Galloway Response
10/30/2024

MISTER CAR WASH

SITE CONSTRUCTION PLANS

STORM LINE 2 (STA: 0+00 TO 2+14.43) – SCALE: H: 1"=20' V: 1"=2'

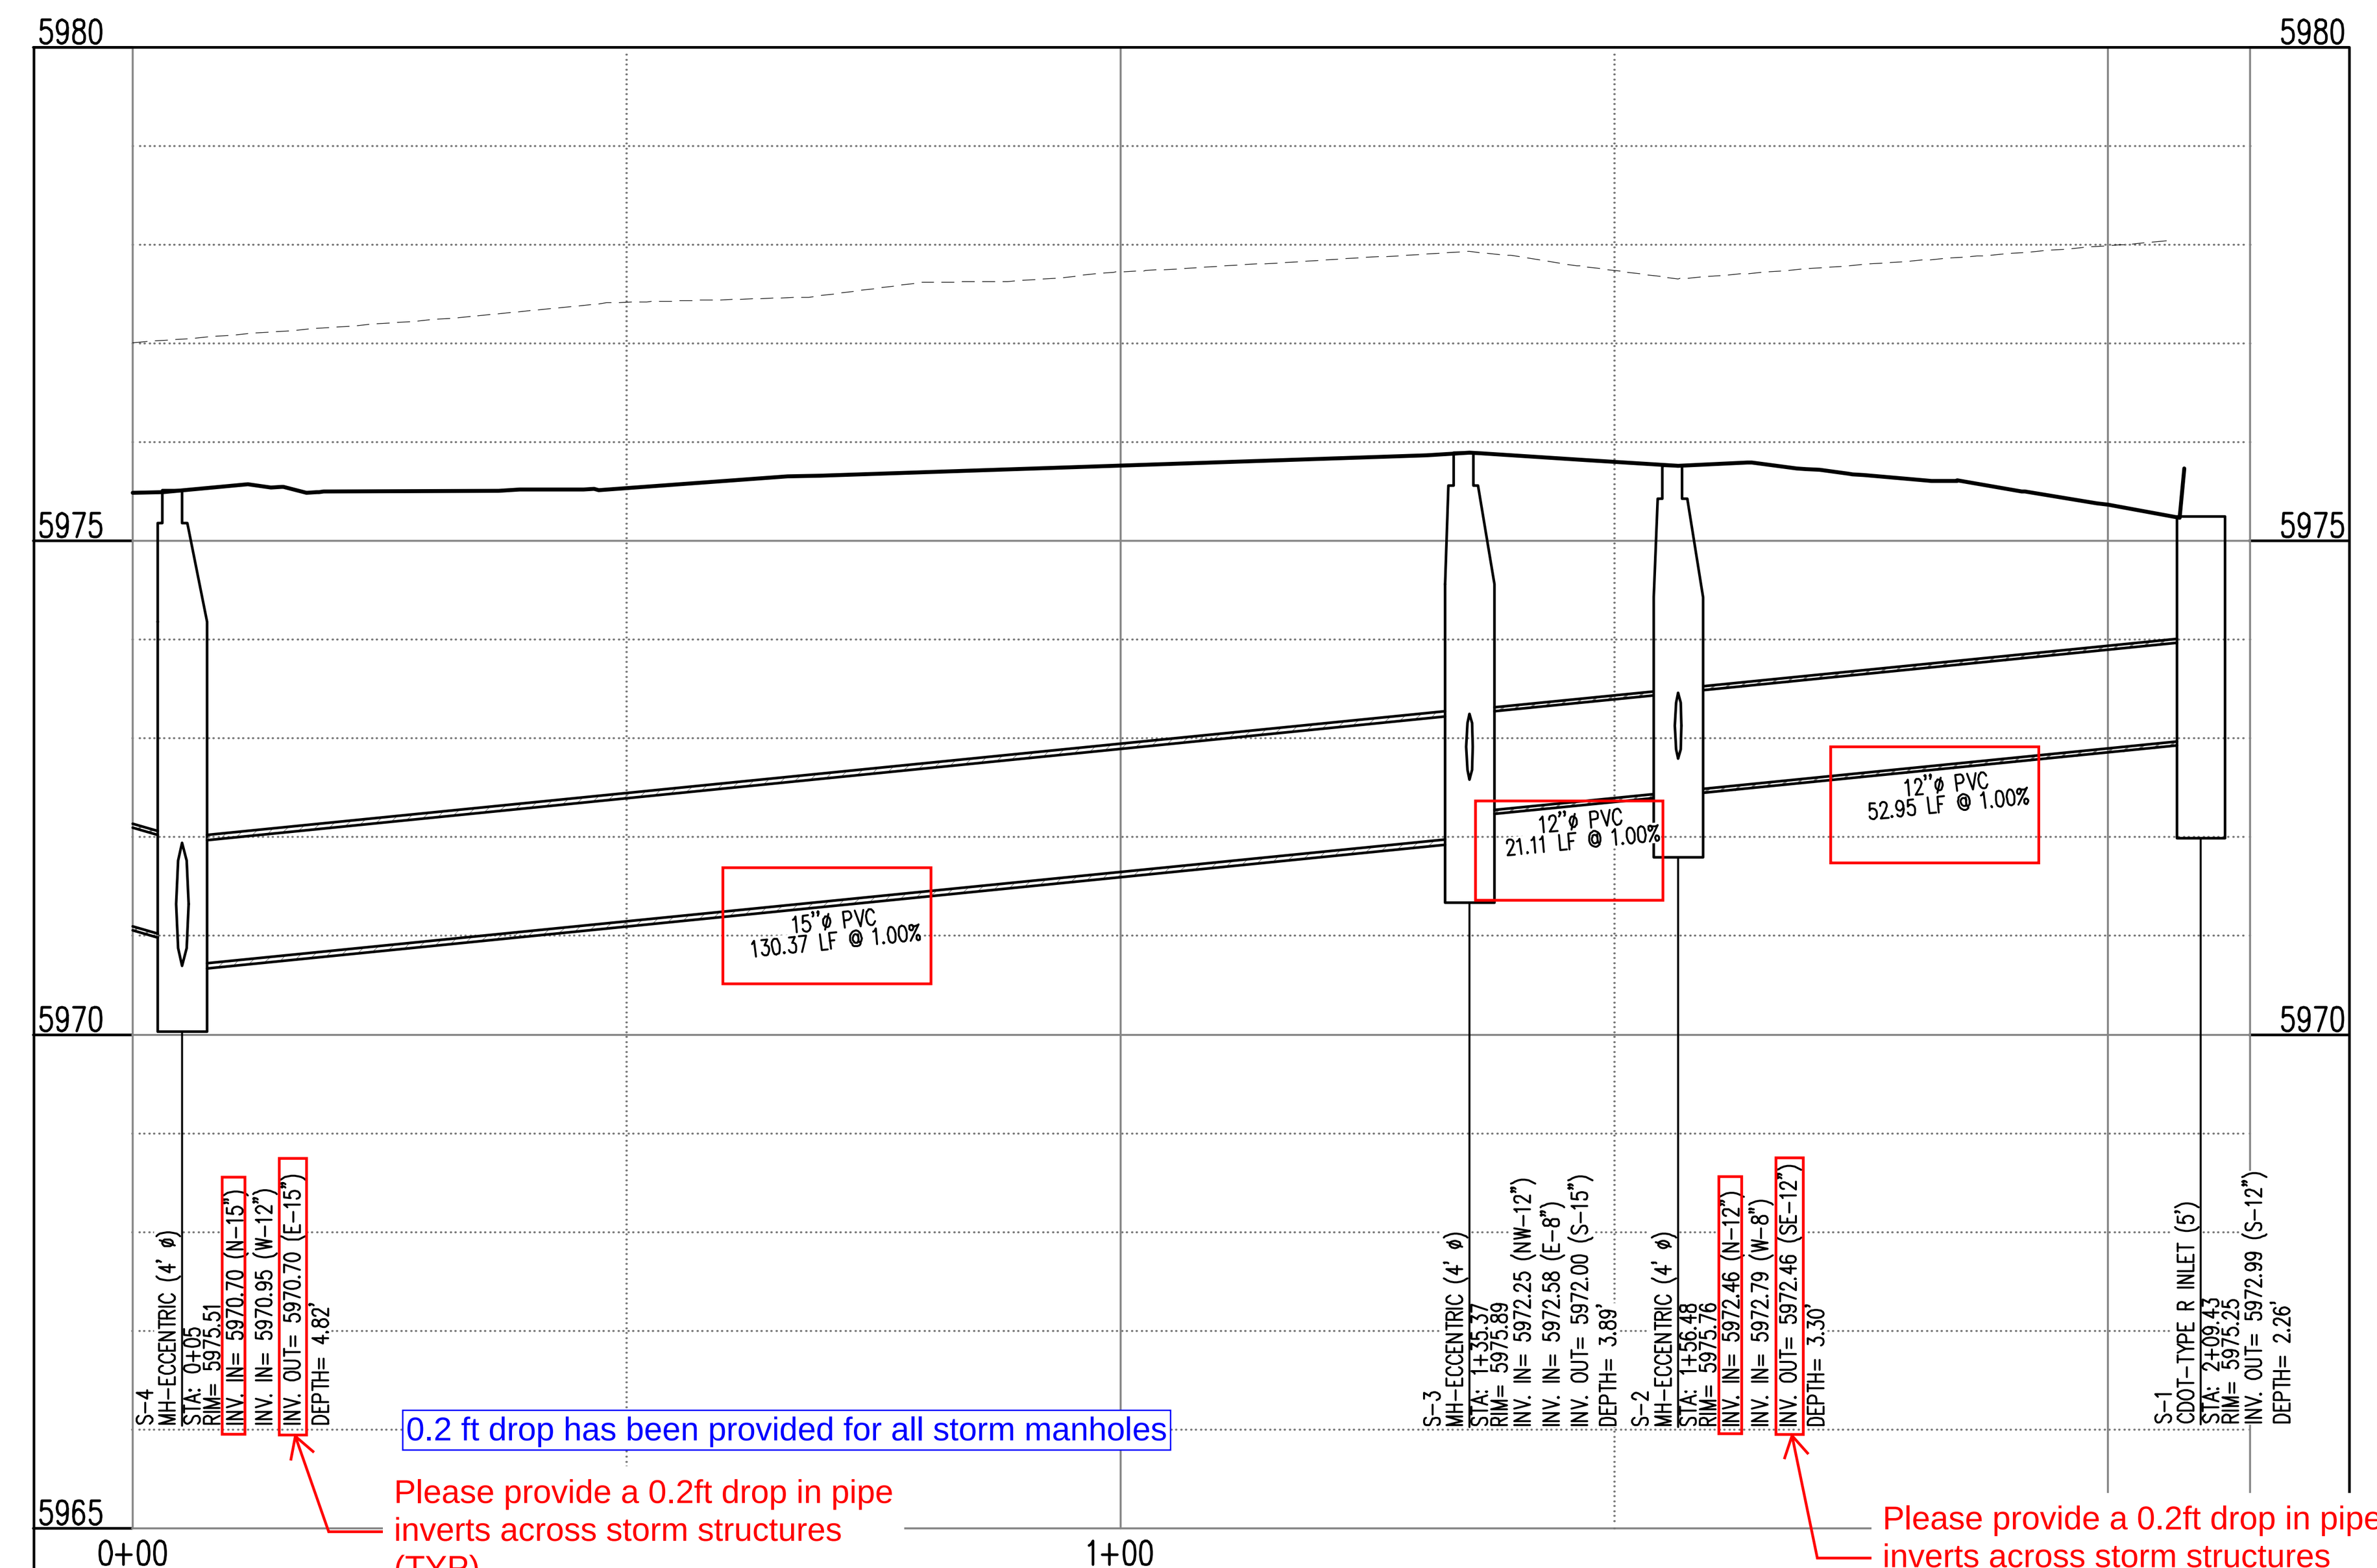
Please provide a 0.2ft drop in pipe inverts across storm structures (TYP)

0.2 ft drop has been provided for all storm manholes
